TRUCK, TRANSPORTER, FLOATING BRIDGE, MC3, W/WINCH, MACK LAUNCH AND RECOVERY VEHICLE (LRV)

LIFT FRAME CUT-OUT SWITCH

MODIFICATION INSTRUCTION

Figure 1 - Lift Frame Cut-Out Switch

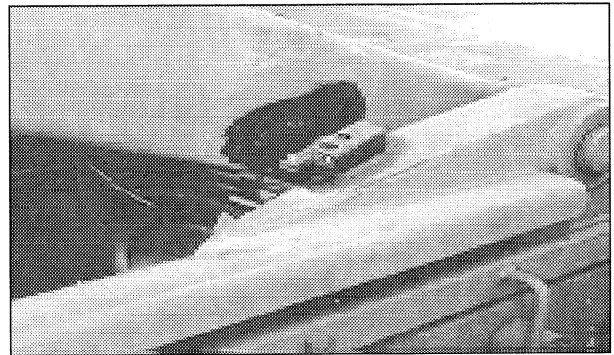
- a. the rear lift frame cut-out switch is changed to a magnetic proximity actuator type and relocated to the position shown in Figure 1;

Figure 2 - Location of Push-Button Switch

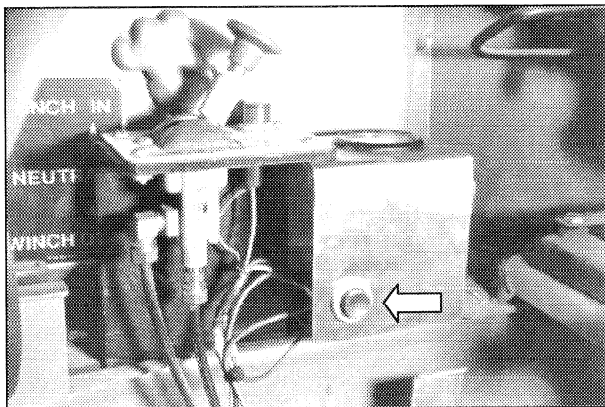
12. Drill and fit push-button switch to the hour meter bracket as shown in Figure 2.

Figure 3 - Mounting Bracket, Switch

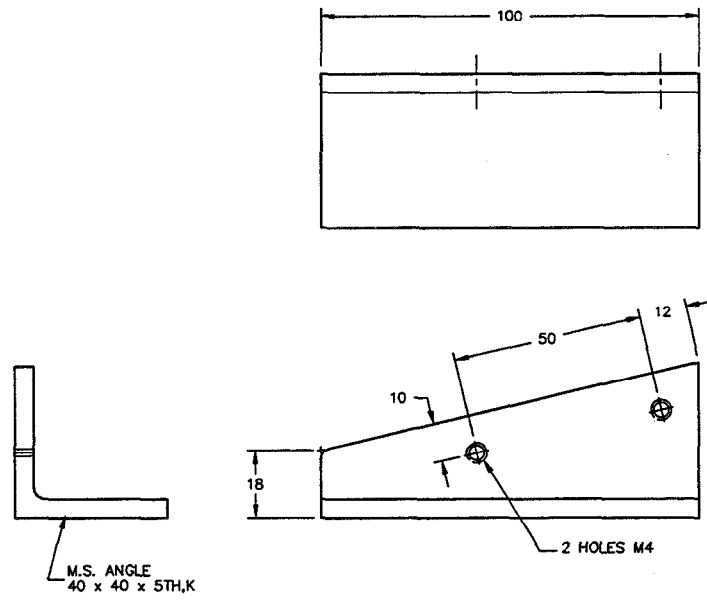
14. Manufacture Mounting Bracket, Switch and Mounting Bracket, Sensor (as detailed in Figures 3 and 4).

Figure 5 - Lift Frame Switch and Bracket Locations

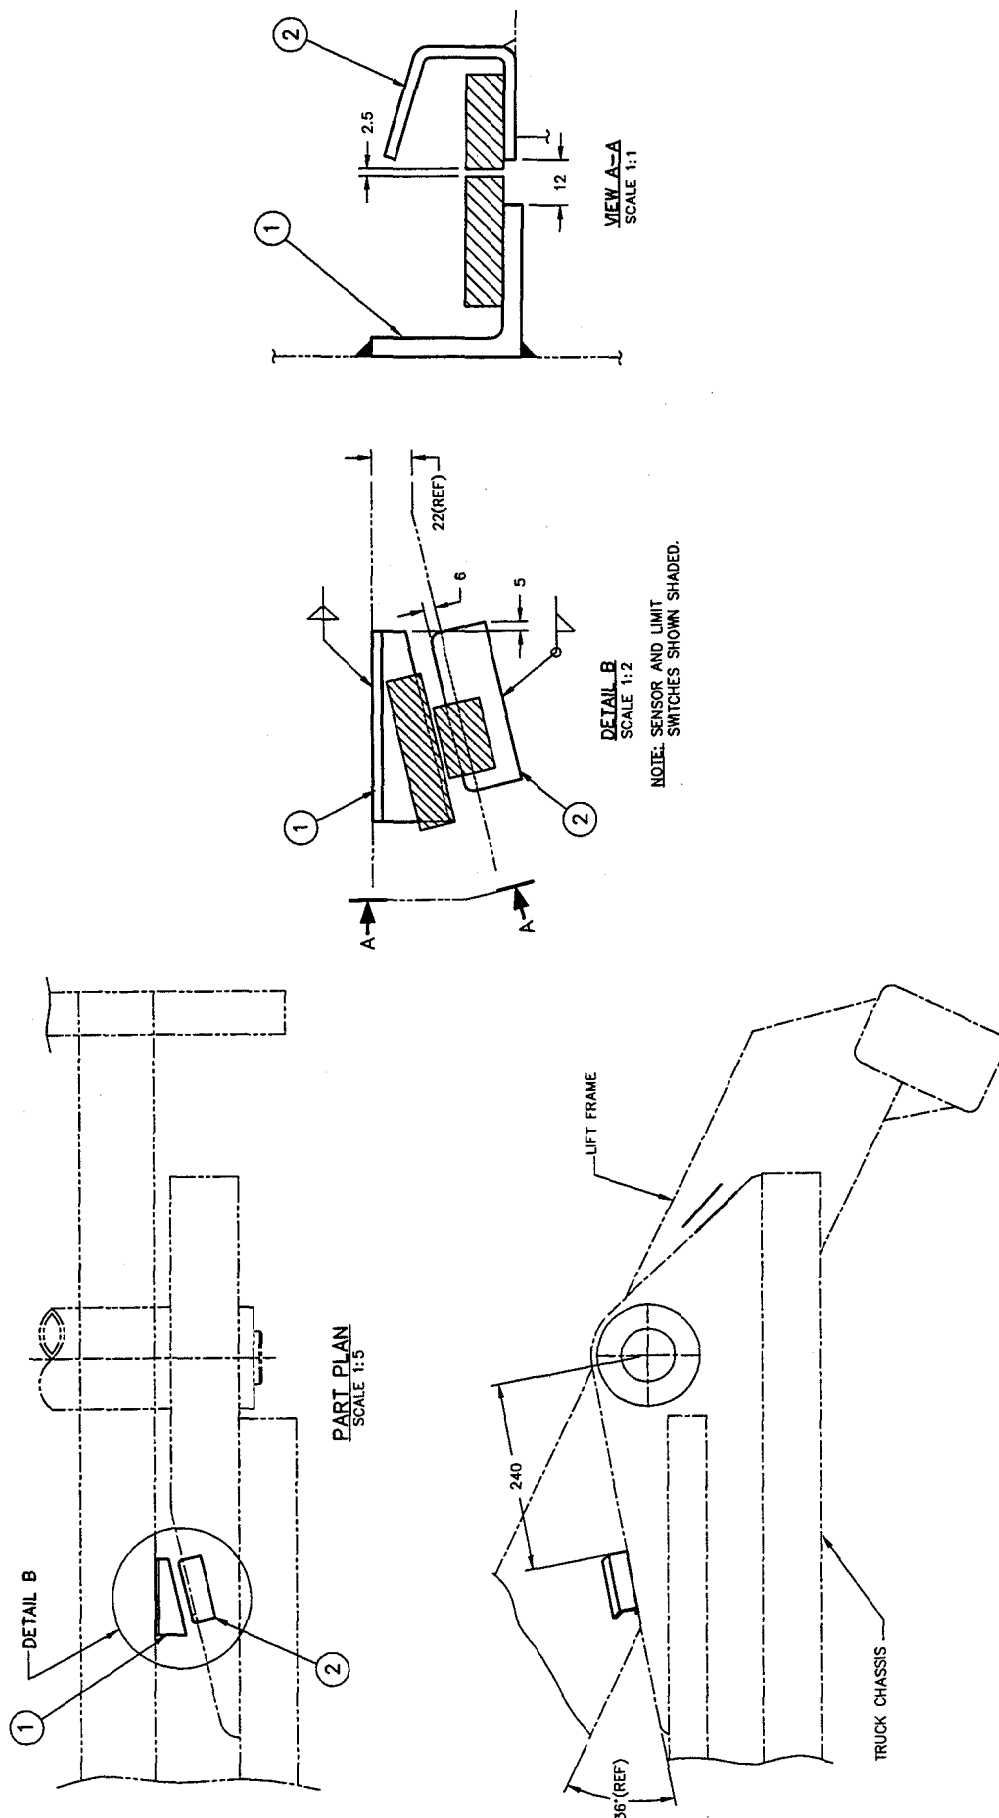
16. Position and weld the Mounting Bracket, Sensor to the chassis (as detailed in Figure 5) and mount the actuator magnet.

17. Mount the proximity switch on the Mounting Bracket, Switch. Position the bracket (as detailed in Figure 5), and tack weld the bracket. Remove the switch prior to completing the weld on the bracket.

Figure 6 - Gap - Actuator Magnet, Proximity Switch

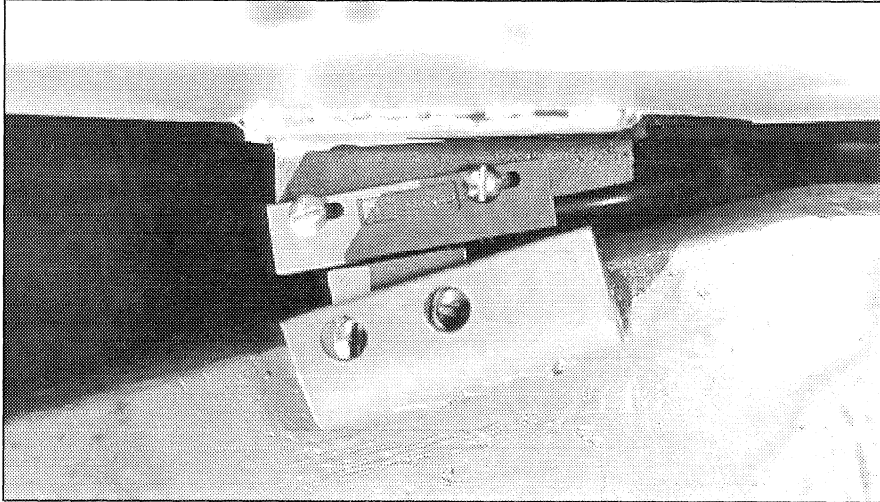
19. Position actuator magnet and proximity switch (as detailed in Figures 5 and 6). The wires from the switch should be positioned under the rear of the lift frame and cross at the pivot to meet up with the wiring to the original switch.

Figure 7 – Wiring Diagram of Proposed Modification

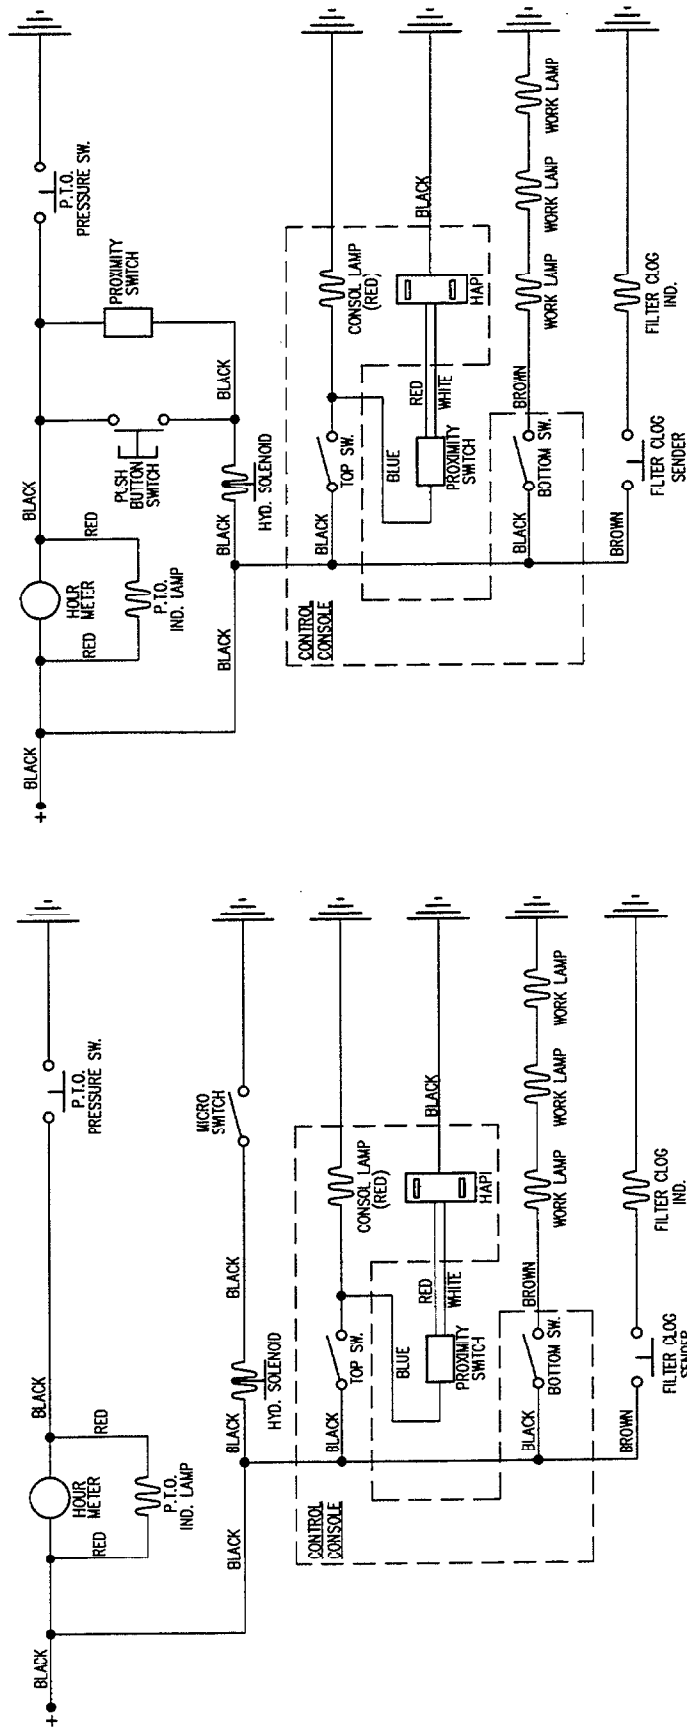
13. Wire switch to the solenoid and to the PTO warning lamp (as detailed in the circuit diagram at Figure 7), using the insulation sleeving and electrical wires as required. The push button switch is the over-ride, should the wiring or switch at the rear of the lift frame fail. Ensure the wiring is positioned in a protected place and enters the cabin through a grommet.

20. Wire in the switch (as detailed in Figure 7). This will entail:

- a. Installing a single wire to the rear of the lift frame from the PTO pressure switch to the proximity switch.
- b. Wiring the magnetic proximity switch so that power is on whenever the lift frame is moving up and down, and that power is off to the solenoid when the lift frame reaches its highest allowable position. This will only require two wires in the switch - the blue common wire and the brown normally closed contact (test that these wires are correct before assembly). One will be connected to the original micro-switch wire by crimp connector and the other to the wire from the PTO pressure switch.
- c. All connections are covered with heat shrink material and wires are secured to the frame by cable ties where required.
